In relation to your request for an extension to provide further information for DA 202139248 at Blocks 13 & 22 Section 22 Kingston.

From: [Billing, Dale](#)
To: purdons@purdon.com.au
Cc: [Varlow, Trent](#); [Richard Davies \(Richard.Davies@act.gov.au\)](mailto:Richard.Davies@act.gov.au)
Subject: DA202139248 Blocks 13 & 22 Section 22 Kingston – Further information request
Date: 17 February 2022 21:18:00
Attachments: [DA202139248 Blocks 13.docx](#)

RESPONSE TO FURTHER INFORMATION REQUEST ON DA 202139248 (B13 & 22 S22 KINGSTON)

Description - PROPOSAL FOR A NEW COMMERCIAL DEVELOPMENT - Demolition of the existing buildings, pavements and structures and construction of a new four-storey commercial building with two level basement carparking, 5 surface carparking spaces, landscaping, removal of one verge crossing from Giles Street and modified vehicle access to the Laneway to the south of Block 22 and associated works.

STRUCTURAL CONSULTANT	ELECTRICAL CONSULTANT	REV	DESCRIPTION	DATE
		1	FOR INFORMATION	24.03.2022
CIVIL CONSULTANT	FIRE ENGINEER			
MECHANICAL CONSULTANT	LANDSCAPE CONSULTANT			
HYDRAULIC CONSULTANT	ACCESS CONSULTANT			
FIRE SERVICES CONSULTANT	CERTIFIER

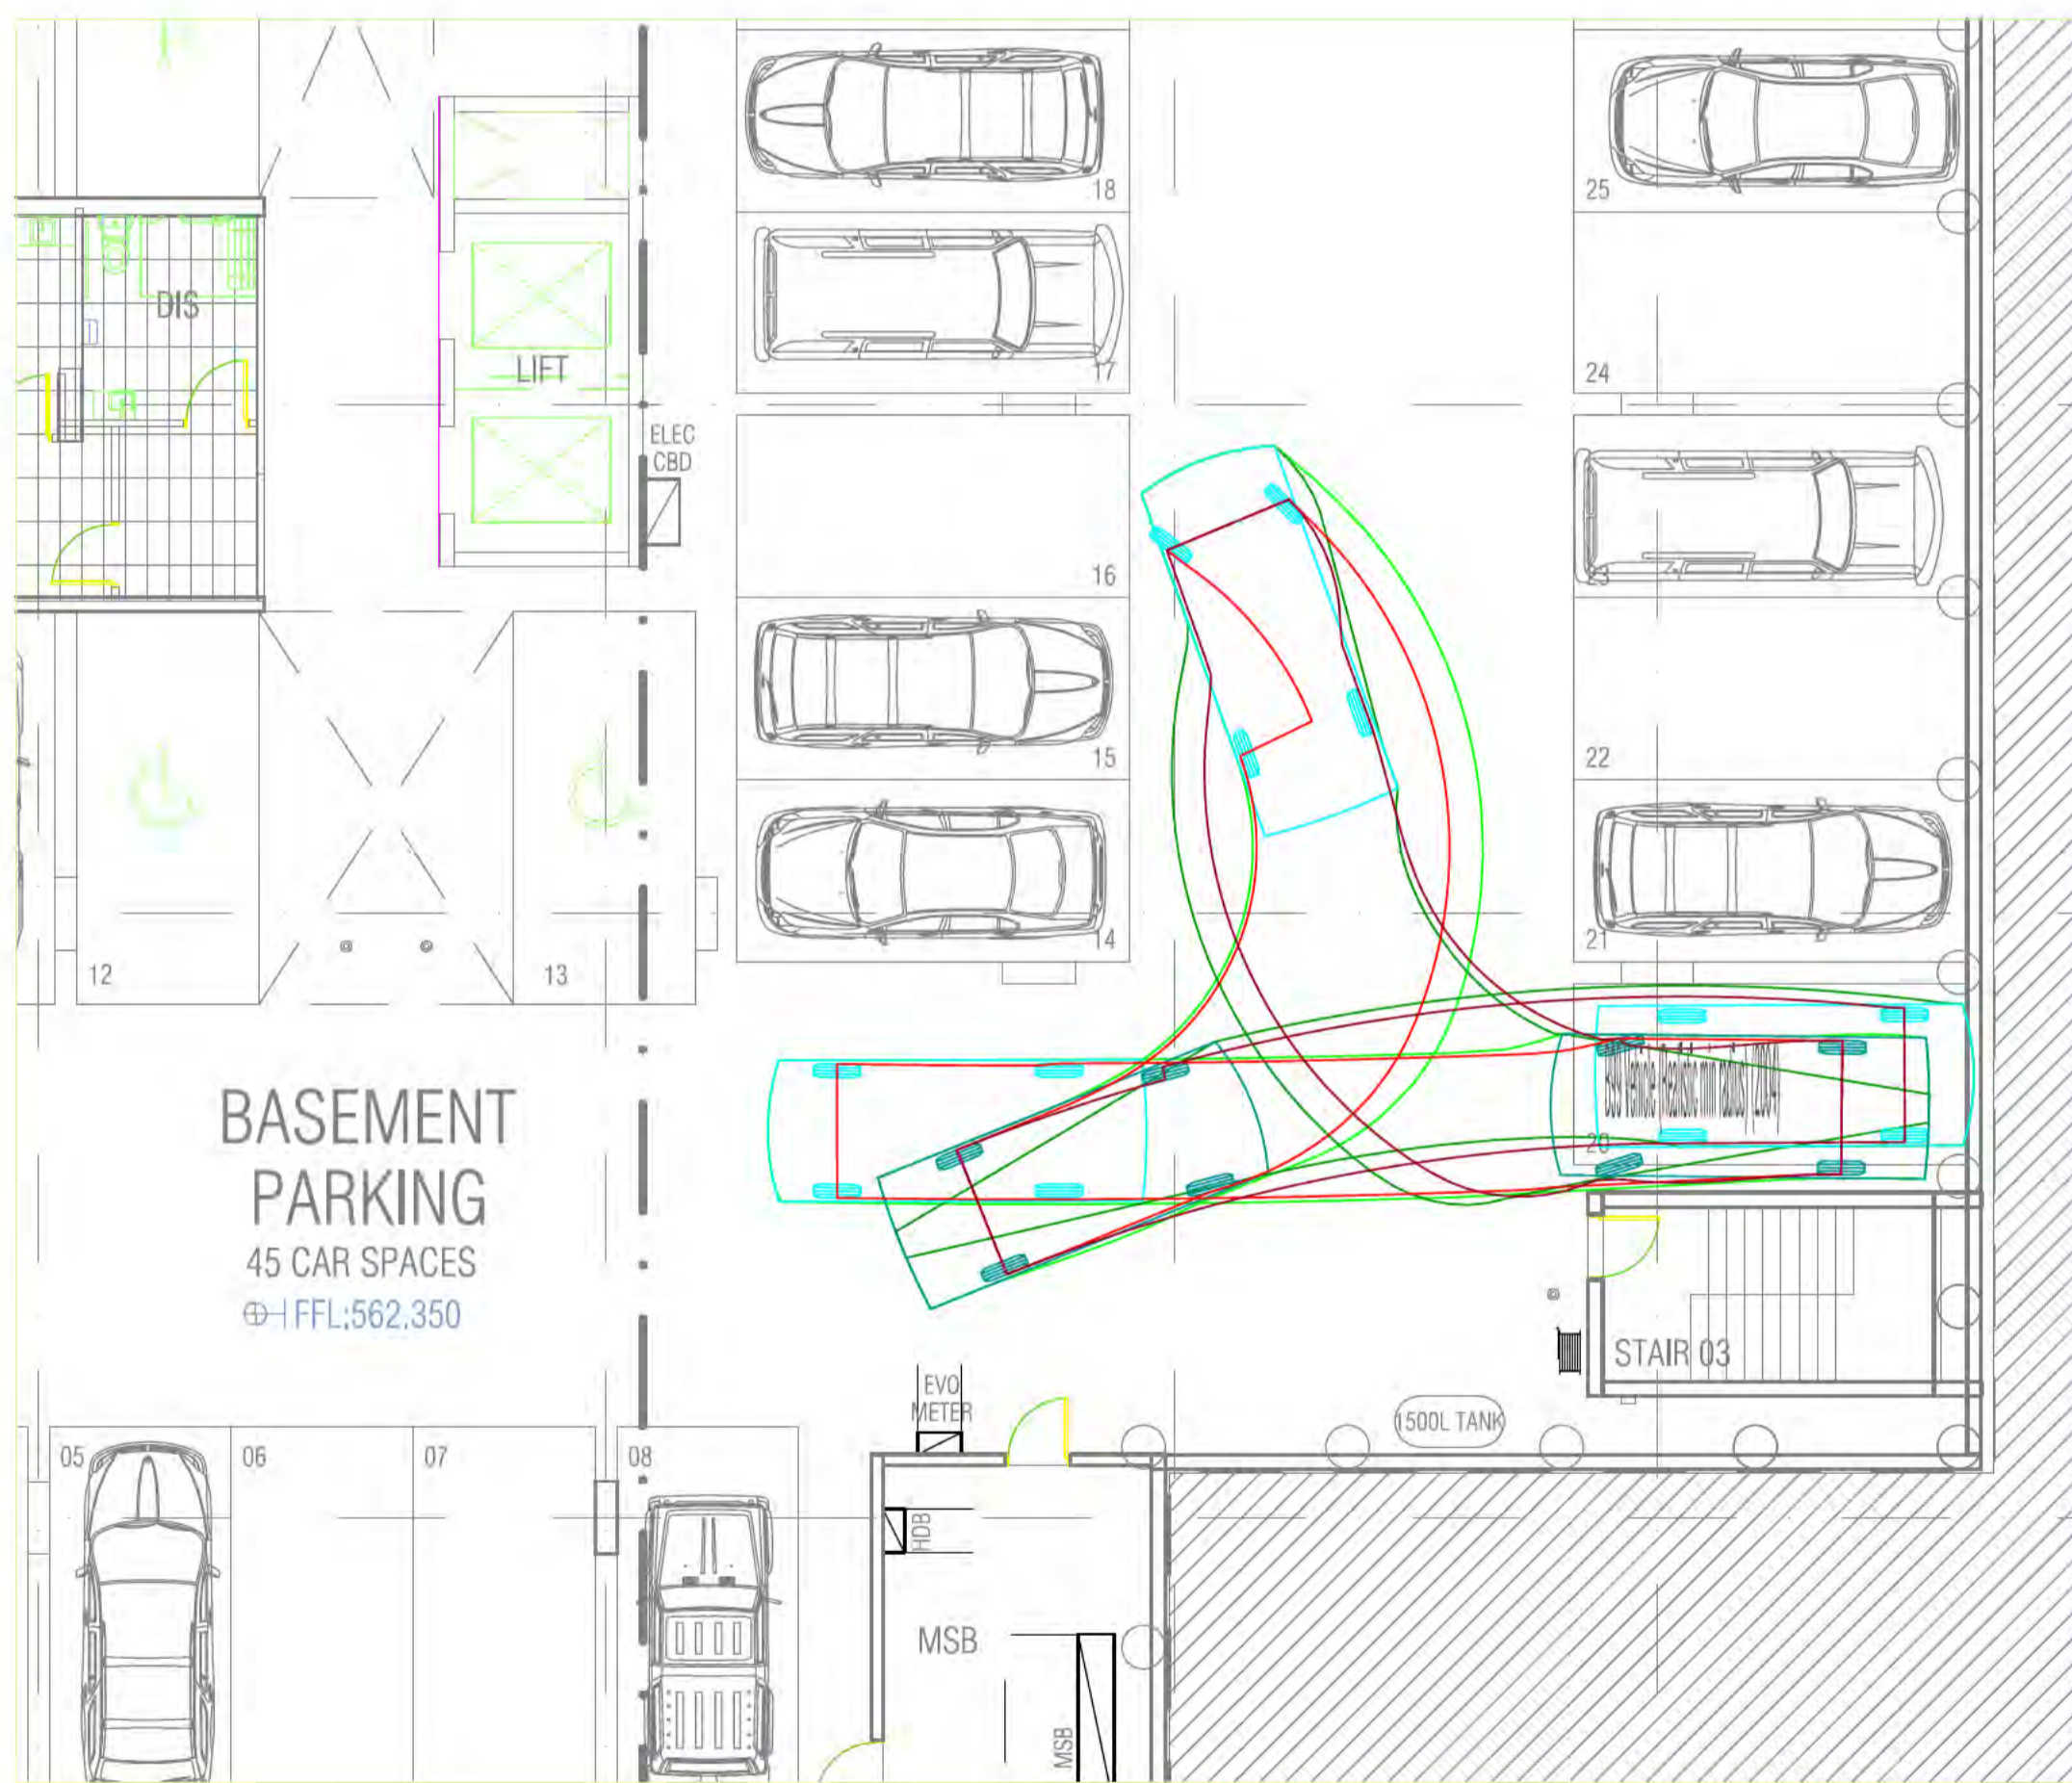
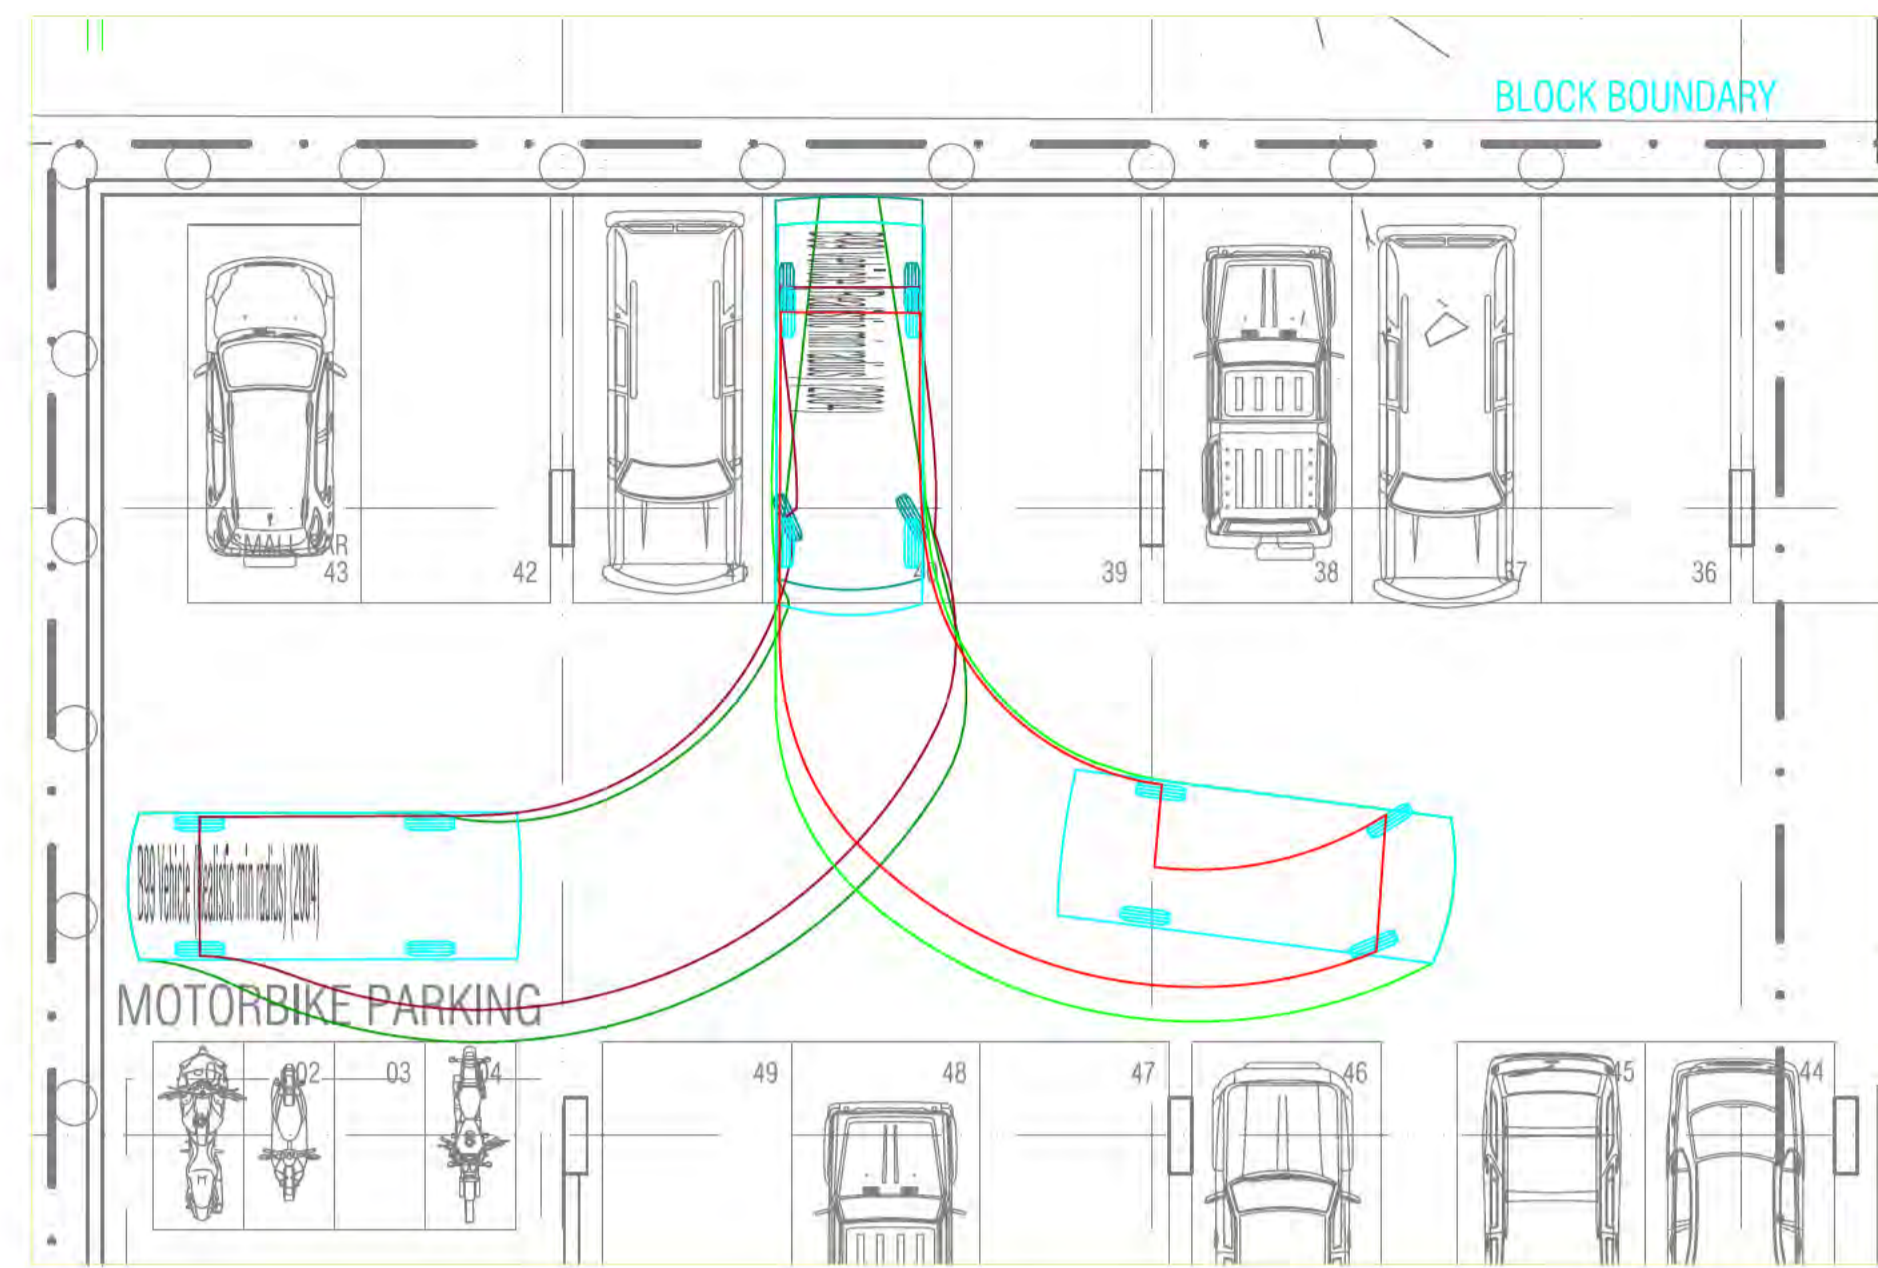
<p>Parking and Vehicular Access General Code</p> <p>Turning templates should be provide for tight turning movements into and out of parking spaces within the basement to demonstrate compliance with turning requirements.</p>	<p>Please refer to additional turning template supplied with this submission.</p>
